Response to Proposed Master Plans and Planning Controls for Pyrmont Peninsula November 2021 – 2021 – 24 Jan 22

Pyrmont Peninsula Place Strategy Implementation Exhibition discussion paper and incorporated Explanation of Intended Effect

The Star Key Site Master Plan – Appendix I Visual Impact Assessment

9.3 Viewpoint 3: Union Square

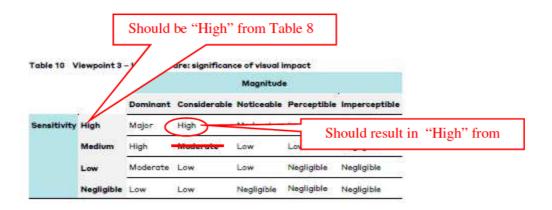
The viewpoint from Union Square seems to have been specifically chosen to lessen the impact of the proposed Metro Tower. This hides the bulk of the tower behind the close Union Square wall of the Harlequin Inn. A more realistic viewpoint aligns to Union St, which is the view presented to the majority of people resting, crossing or participating in community events in the square. This is shown in the following simulated image with representative tower in relation to buildings of the same distance.

Contrary to the assessment, the proposal **will directly impact** on the key visual values of Union Square!

The assessment in the tables has major errors to make Metro Tower seem to have minimal impact on the visual values of Union Square with its unique mix of local buildings that reflect the 19 century aspect of this valuable space in Pyrmont and Sydney.
